STATE OF HAWAII
DEPARTMENT OF TRANSPORTATION
HIGHWAYS DIVISION
HONOLULU, HAWAII
"AS-BUILT"
PLANS FOR
OLD KEA'AU-PAHOA ROAD RESURFACING
KEA'AU TO KEAAU HIGH SCHOOL
PROJECT NO. 139A-01-05M
DISTRICT OF PUNA
ISLAND OF HAWAII

CHANGES MADE DURING CONSTRUCTION HAVE BEEN INCORPORATED ON THESE PLANS EXCEPT CHANGES IN THE ORIGINAL THEORETICAL QUANTITIES. FOR ACTUAL QUANTITIES, REFER TO PROJECT LEDGER AND/OR COMPUTATION BOOK.

**PAVEMENT MARKING
AND SIGNING PLAN**

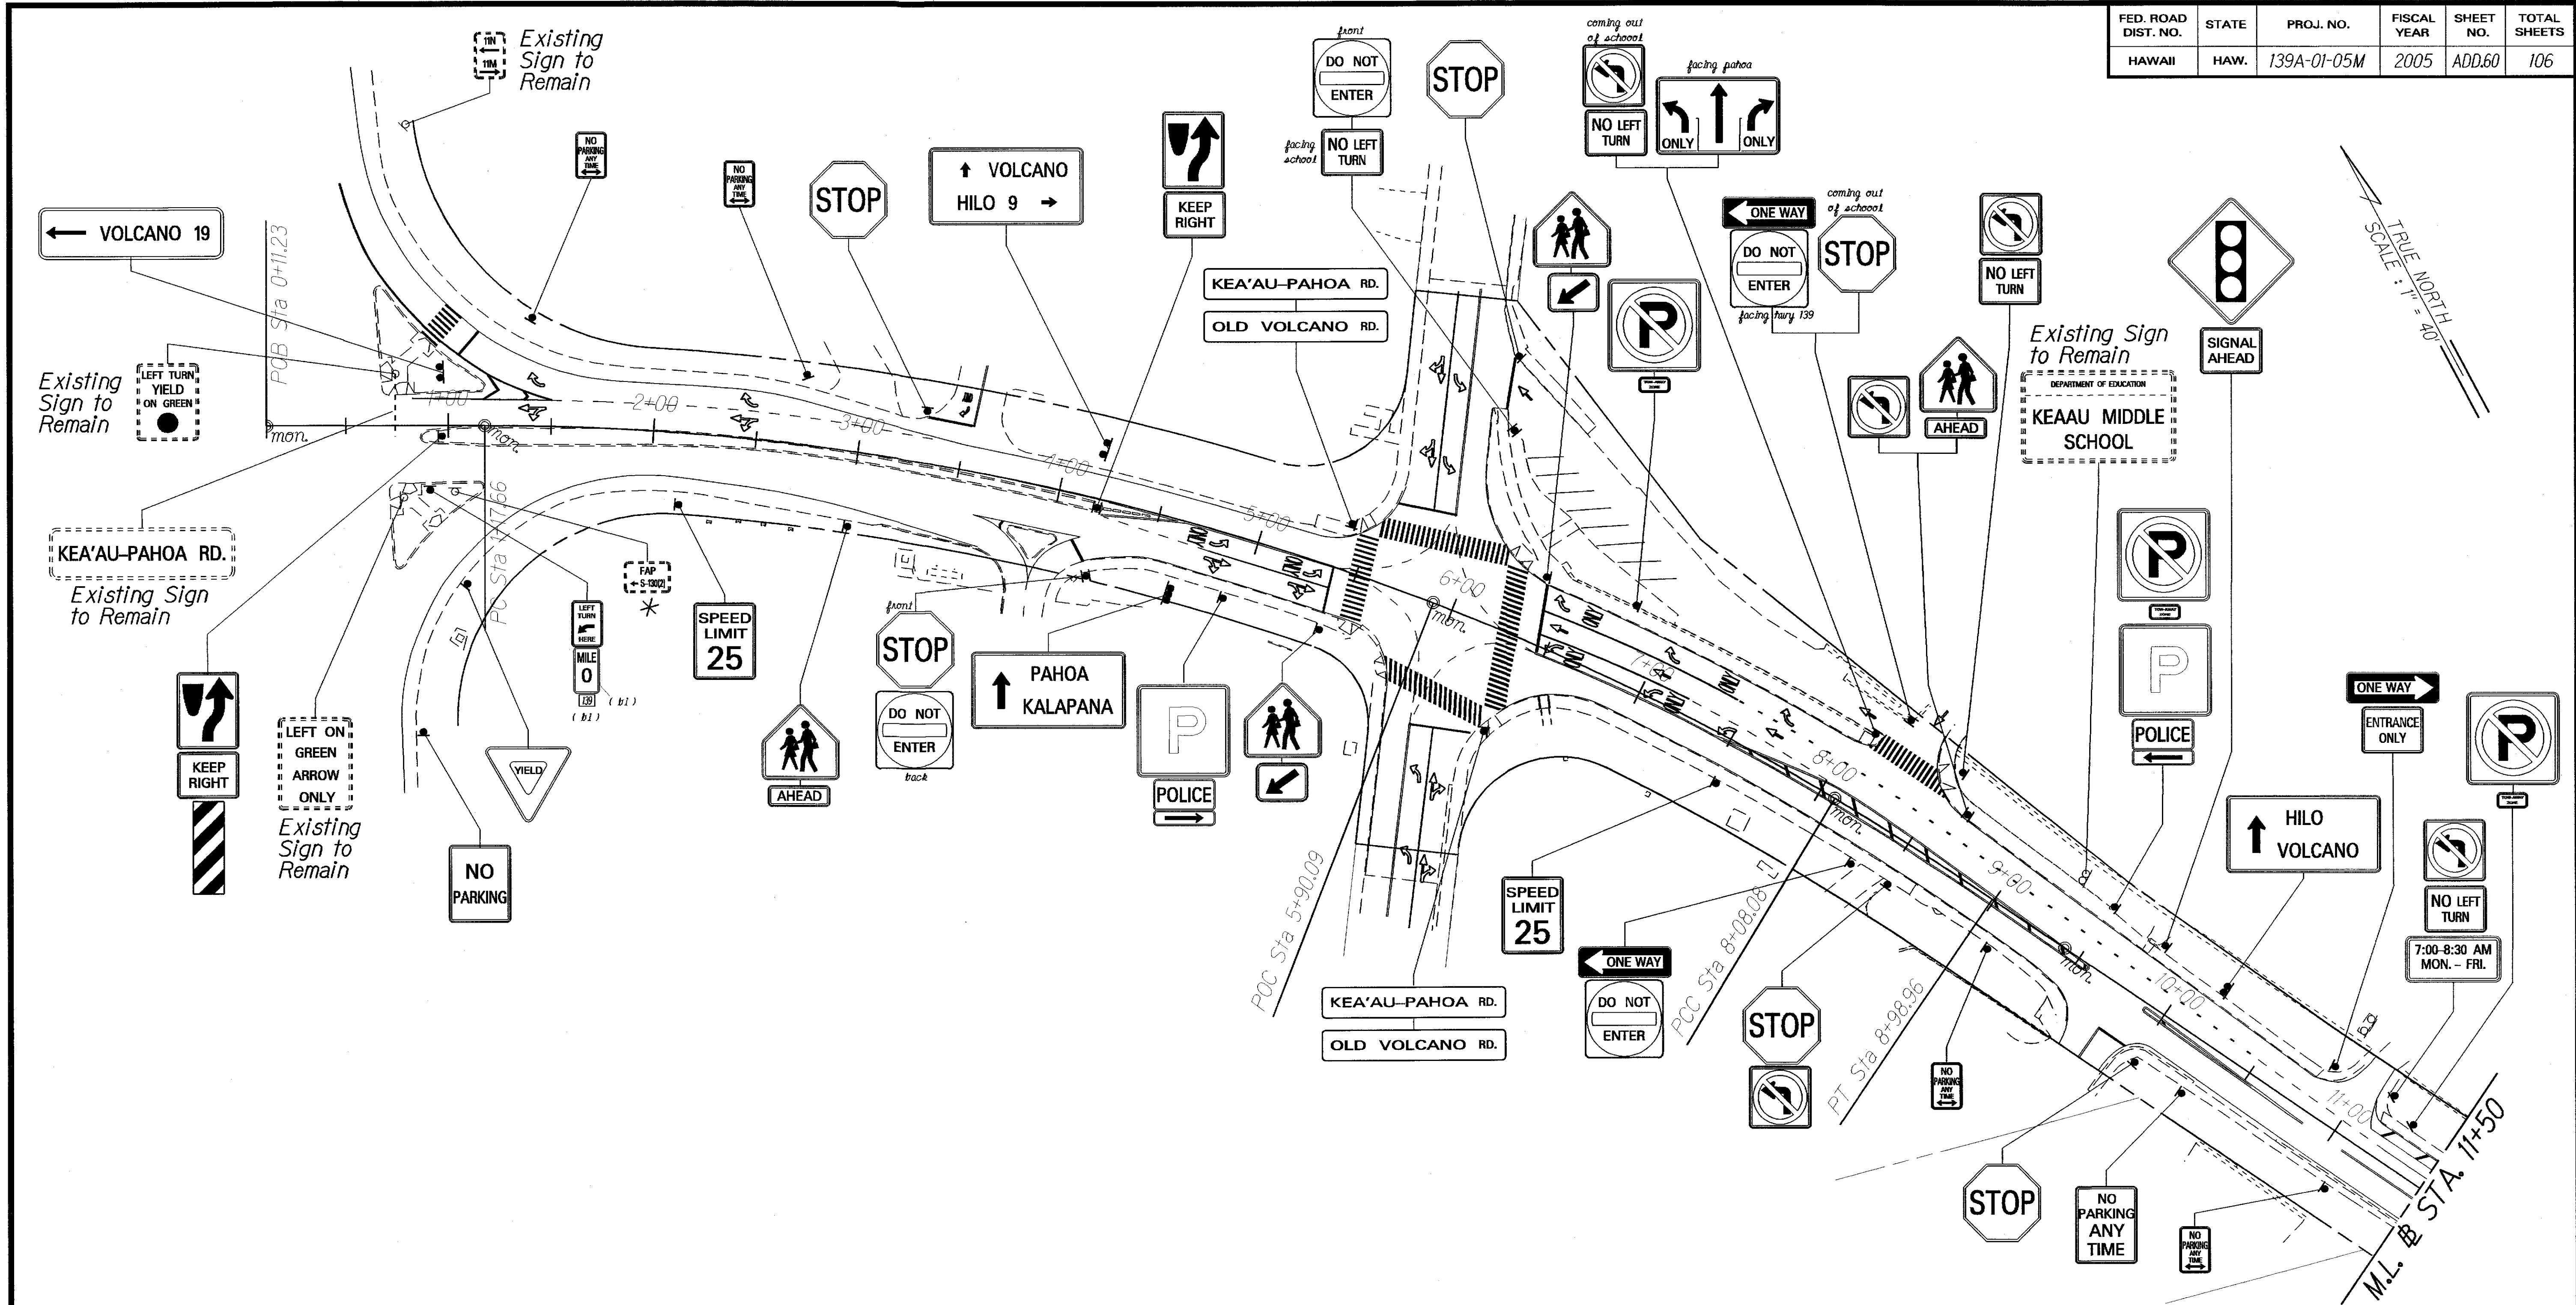
6/07/07	Remove bike lane striping and sign. Correct note on sign, per Addendum No. 1.
DATE	REVISION

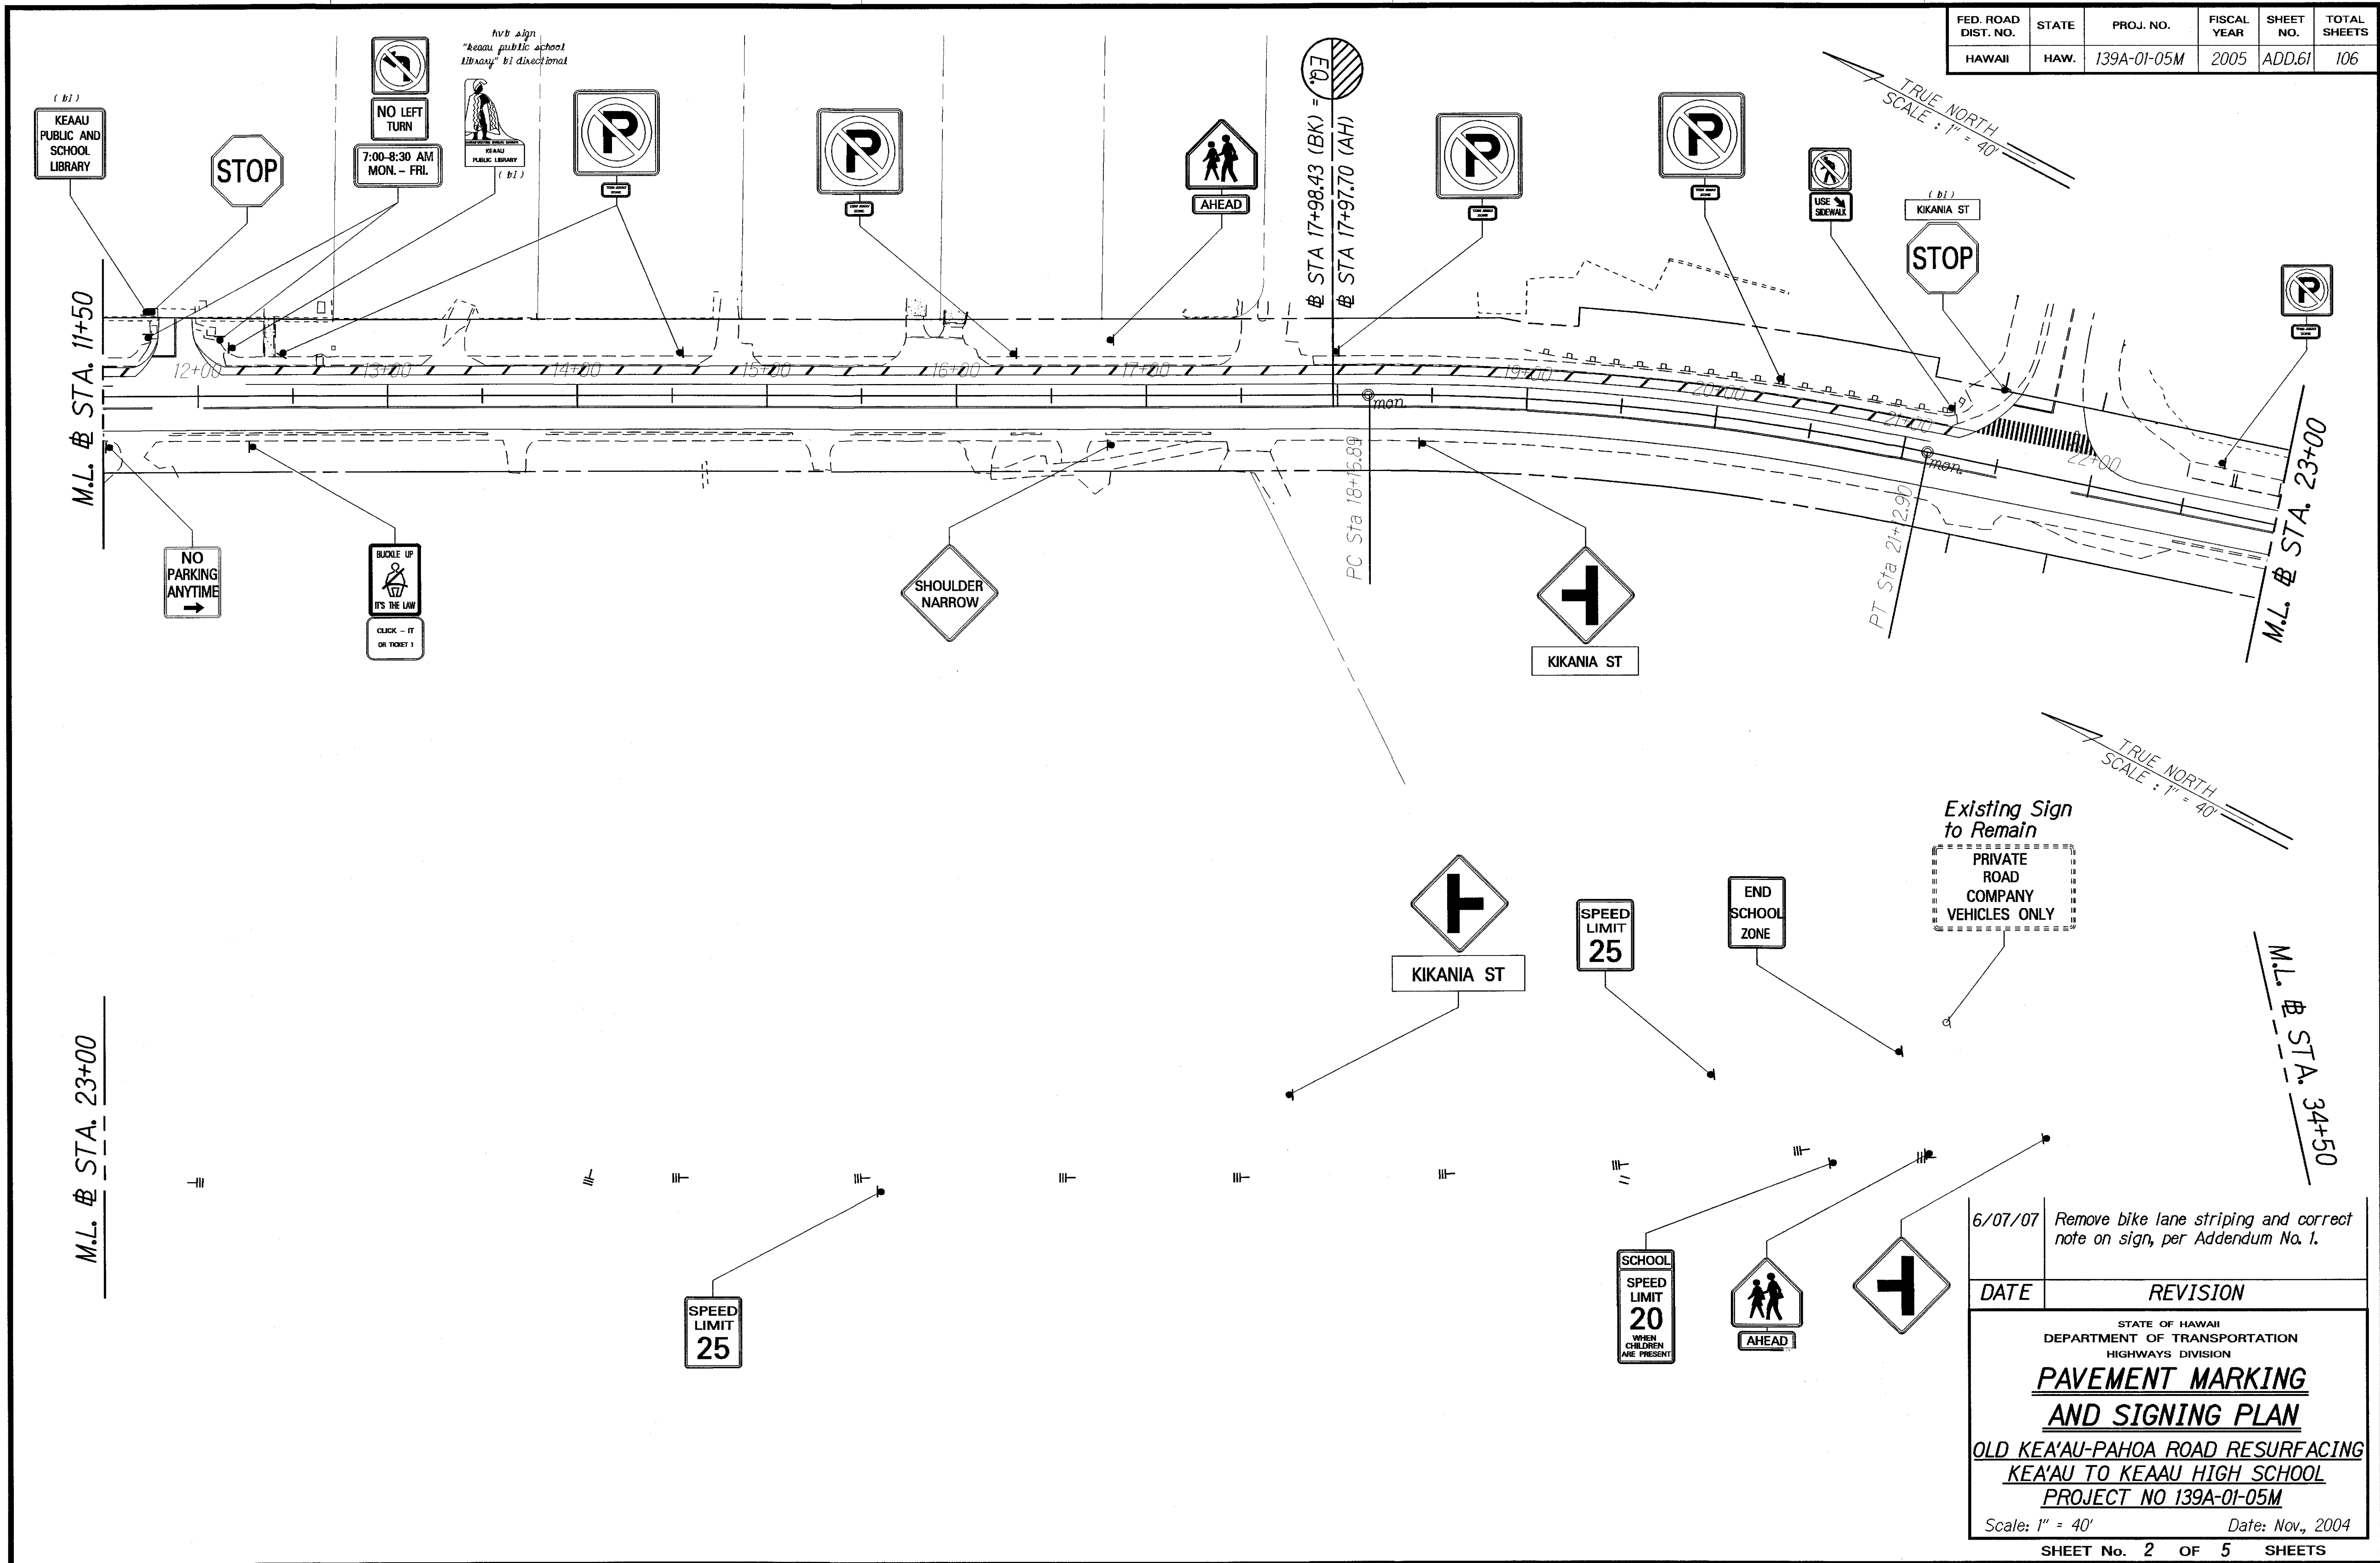
6/07/07	Remove bike lane striping and correct note on sign, per Addendum No. 1.
DATE	REVISION
STATE OF HAWAII DEPARTMENT OF TRANSPORTATION HIGHWAYS DIVISION PAVEMENT MARKING AND SIGNING PLAN OLD KEA'AU-PAHOA ROAD RESURFACING KEA'AU TO KEEAU HIGH SCHOOL PROJECT NO 139A-01-05M Scale: 1" = 40' Date: Nov., 2004 SHEET No. 2 OF 5 SHEETS

PAVEMENT MARKING
AND SIGNING PLAN

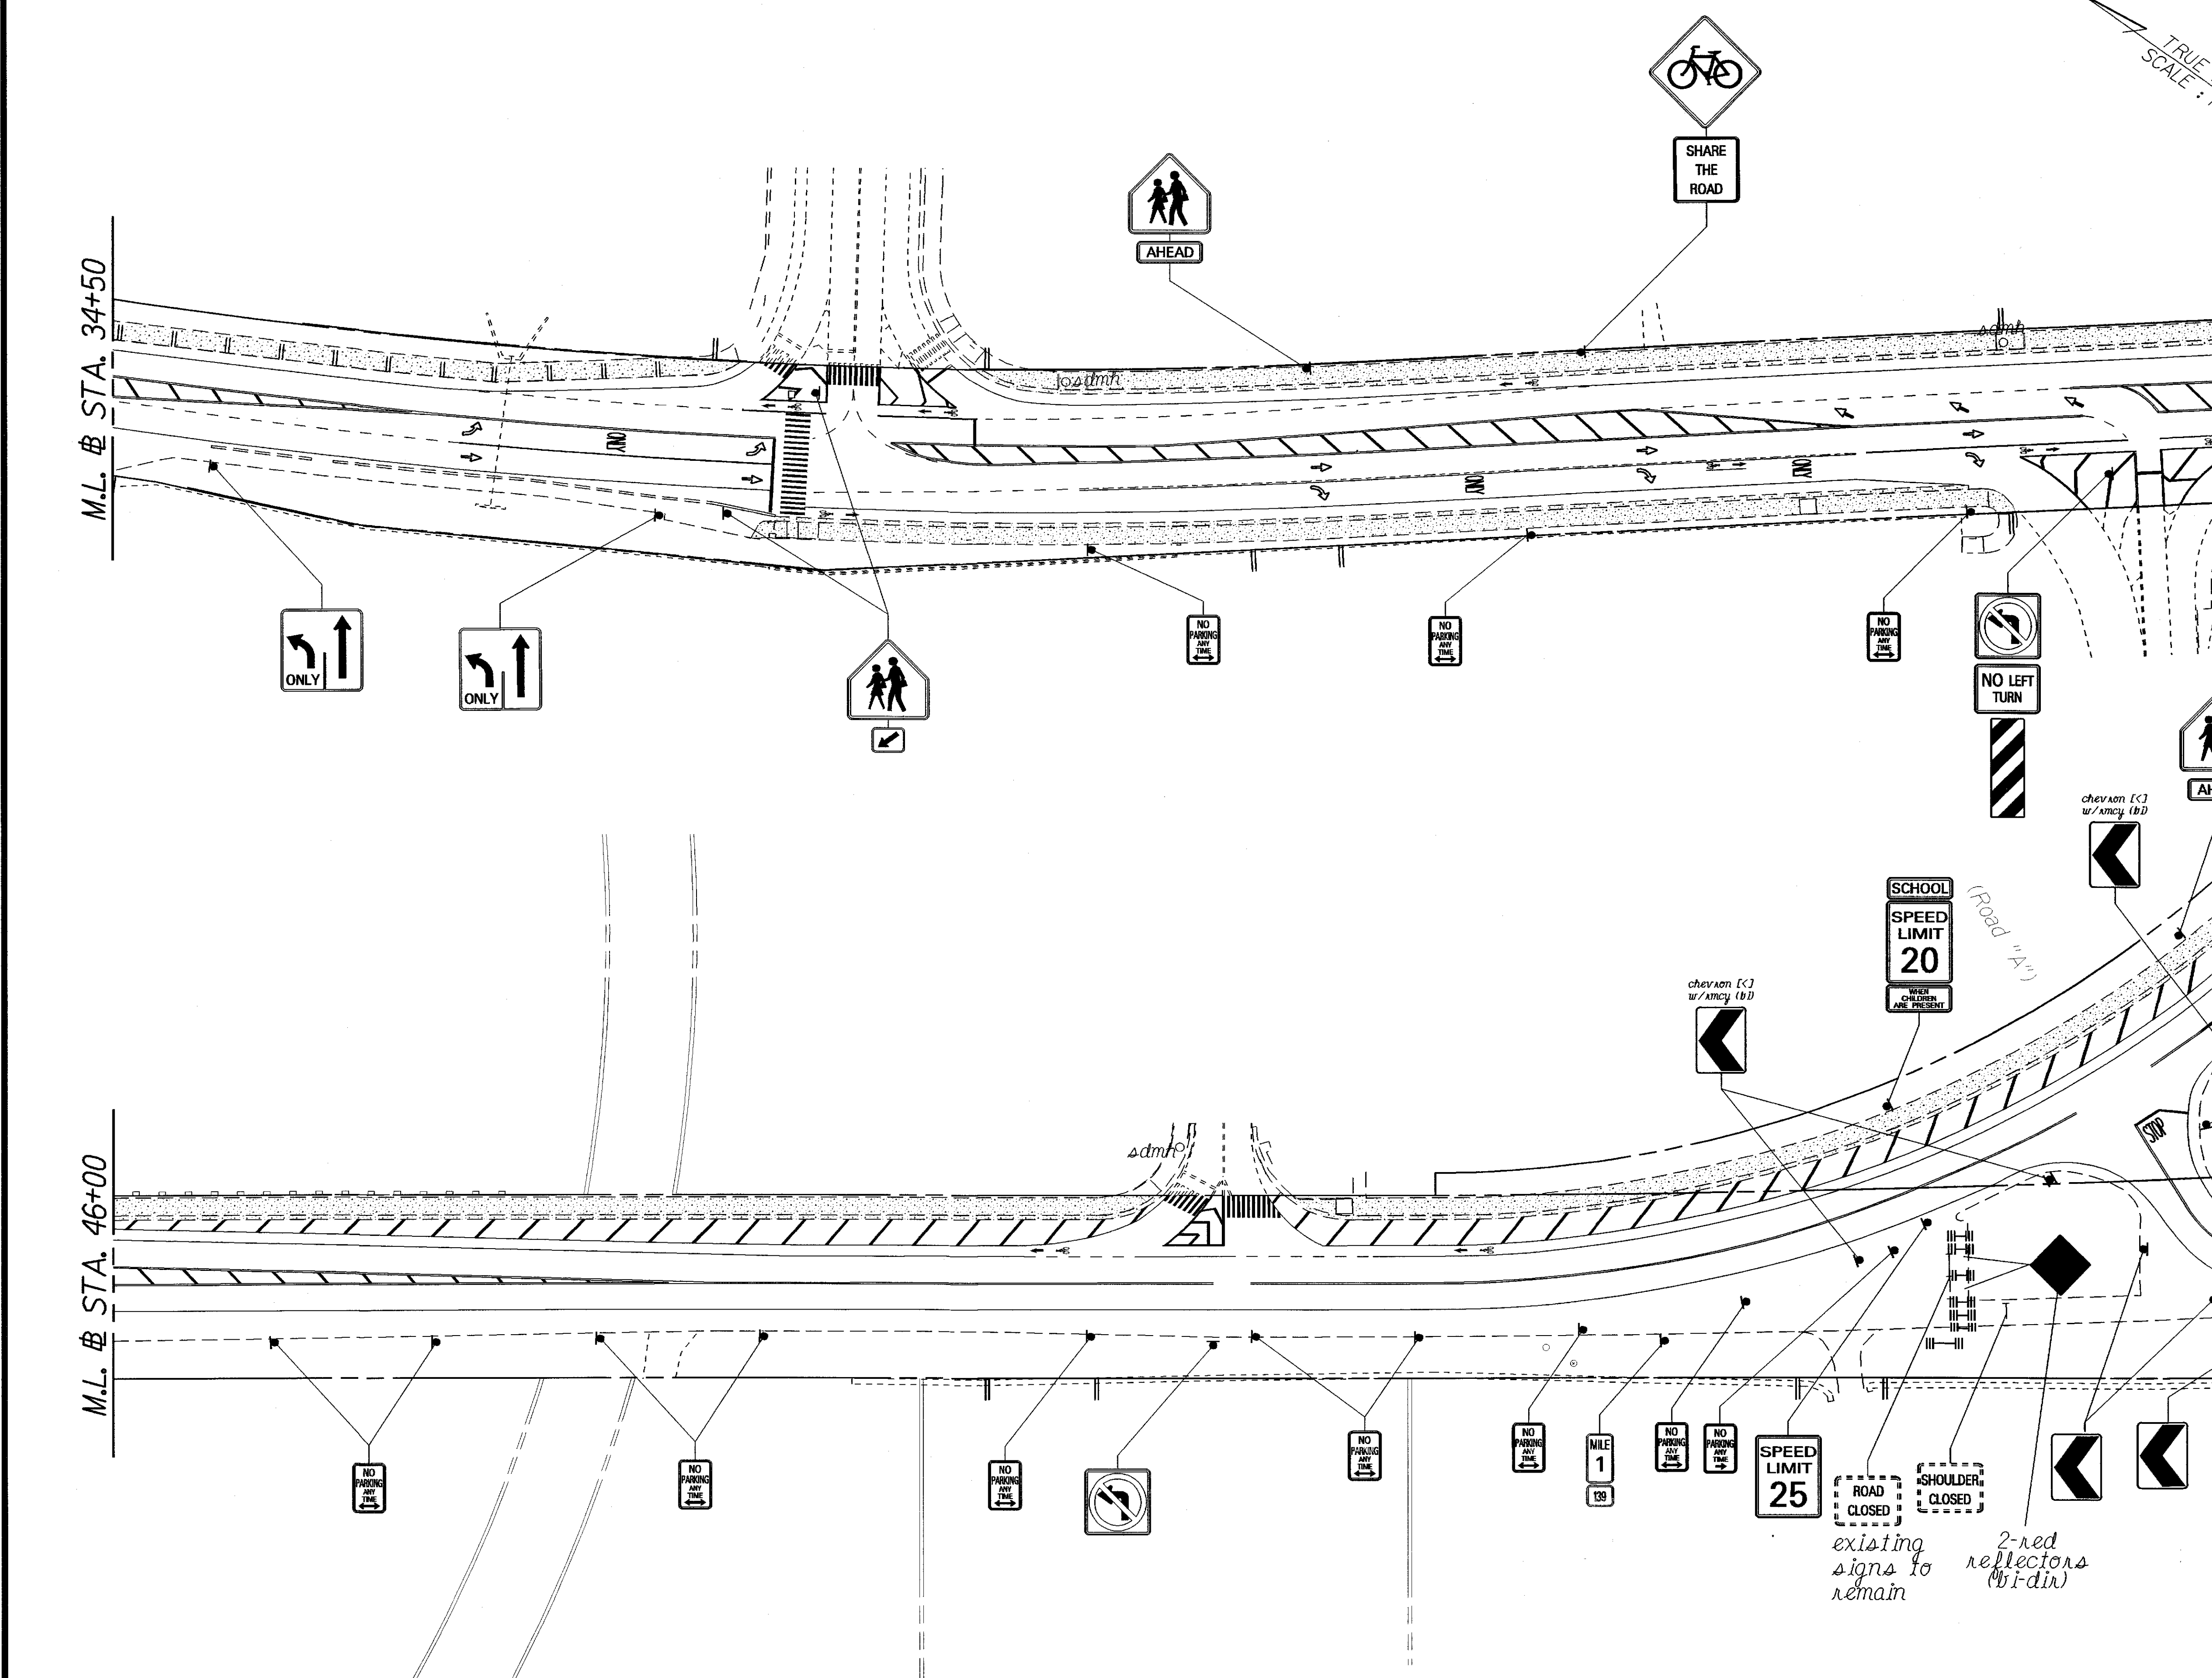
6/07/07	Revised pavement markings and add two new signs, per Addendum No. 1.
DATE	REVISION
